Point Beach Nuclear Plant, Unit 2
Docket 50-301
Renewed License No. DPR-27

10 CFR 50.55a Request, Relief Request RR-4L2
Inservice Inspection Impracticability
Examination Limitations Due to Configuration
Fourth Ten-Year Inservice Inspection Program Interval
Response to Request for Additional Information

10 CFR 50.55a REQUEST, RELIEF REQUEST RR-4L2 INSERVICE INSPECTION IMPRACTICALITY EXAMINATION LIMITATIONS DUE TO CONFIGURATION FOURTH TEN-YEAR INSERVICE INSPECTION PROGRAM INTERVAL RESPONSE TO REQUEST FOR ADDITIONAL INFORMATION

Figure 3-2. Steam Outlet Nozzle and Venturi Insert Assembly Details

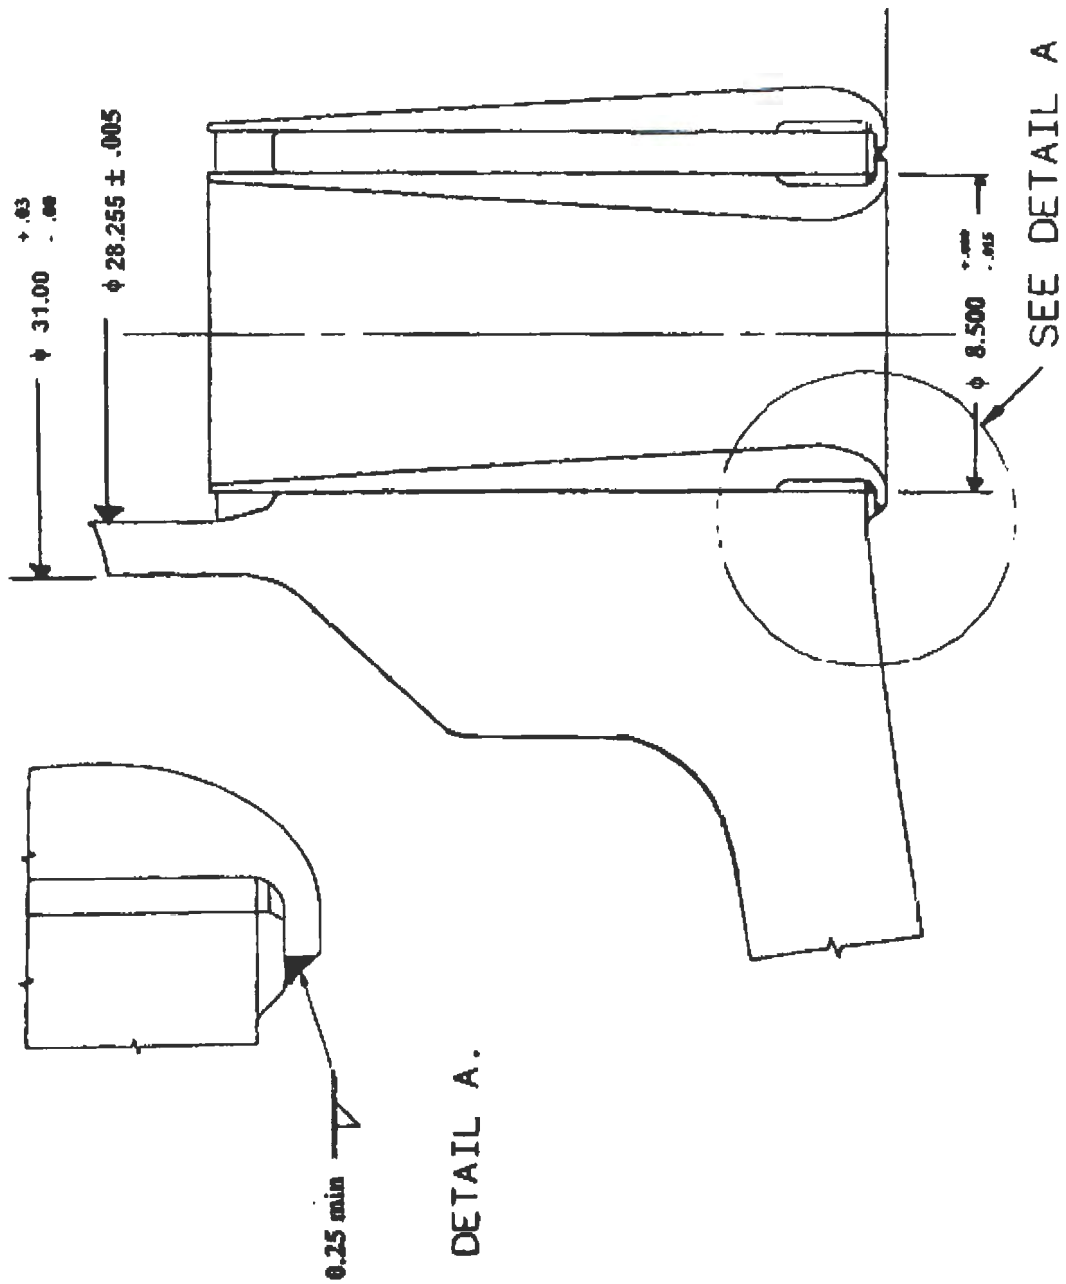
- 1. The drawing of the flow restrictor provided appears to show that the flow restrictor is constructed of clad ferritic steel, but this is not explicitly stated in the relief request. Please describe the materials of construction for the flow restrictor.*

- a. The Steam Nozzle Flow Limiter shown in Figure 4L2-1 is fabricated from the following components:

Steam Outlet Nozzle
Venturi Inserts (7)

SA-508 Class 3A
SB-564 (Inconel 690)

A 0.22" thick weld overlay of Inconel 52 was deposited on the Steam Outlet Nozzle. The Venturi Inserts are welded to this overlay with Inconel 52.

b. See below Drawing for additional details:
